<b>sabena</b> <b>B707</b>	Module: E&E + LWR NOSE C	A/C Reg :	Check :	 <b>D4G2000001</b>
	Oper. : NRT			
	Type : MODIF	Issuer : A59513	Cert.St.: 45379	
Spec. : ELECTRICIAN	Release Date: 30.11.2007		Page 1 of 6

DFW B707-24-003 rev 0      WIRNG ON R5 EXT. PWR CONTACTOR CORRECTION

<b>EI-Number:</b> DFW B707-24-003 <b>Component / Equipment Type:</b> Electrical Power	<b>Rev.:</b> 1 <b>Date:</b> 20 - Nov - 2007
--	--

FIGURE 1 \_ WIRE MODIFICATION LX-N19997 and LX-N20000

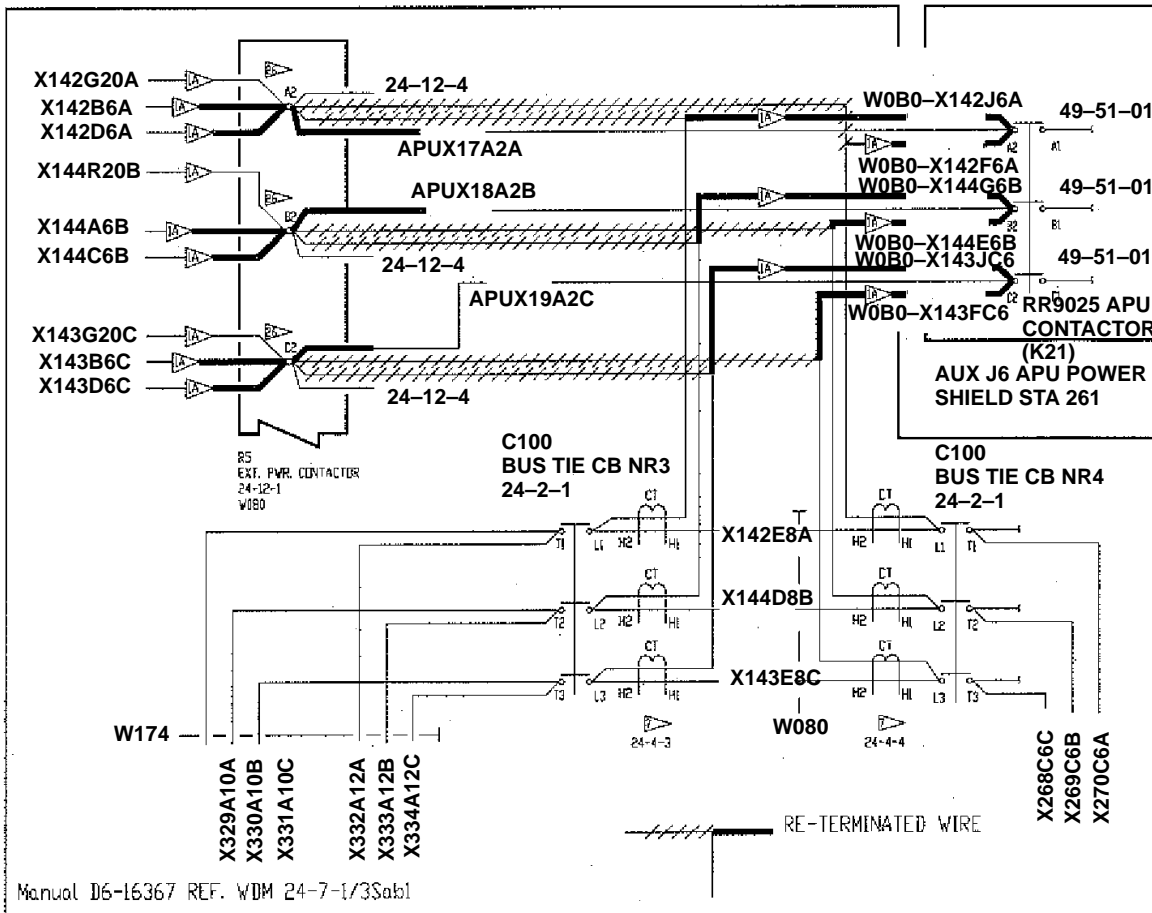
**NOTE:** FOR LX-N19997 JUST RE-CRIMPING ON THE EXTERNAL POWER CONTACTOR & IN THE AUX J6 APU POWER CONTACTOR IS TO BE CARRIED OUT ALLOWING THE TERMINAL STUDS TO SECURED IAW SWPM.

3. Identify wires iaw SPM 20-10-11, paragraph 11, using item 4.
4. Perform wiring modification as shown in figure 1, using item 1( High temp wire, BMS13-60), 2 ( Terminal, MS20659-120 ) & 3 (Heat shrinkable sleeve, MS23053-5).

5. Crimp together the 2 x 06 gauge & 1 x 02 gauge wires ( on the external power contactor R5 & on the aux J6 APU power contactor RR9025). Crimp according to Boeing SWPM 20-30-11. Terminal lug: P/N MS20659-120 ( opt P/N BACT12AC36, opt P/N MS25036-136, opt P/N BACT12M26-3).
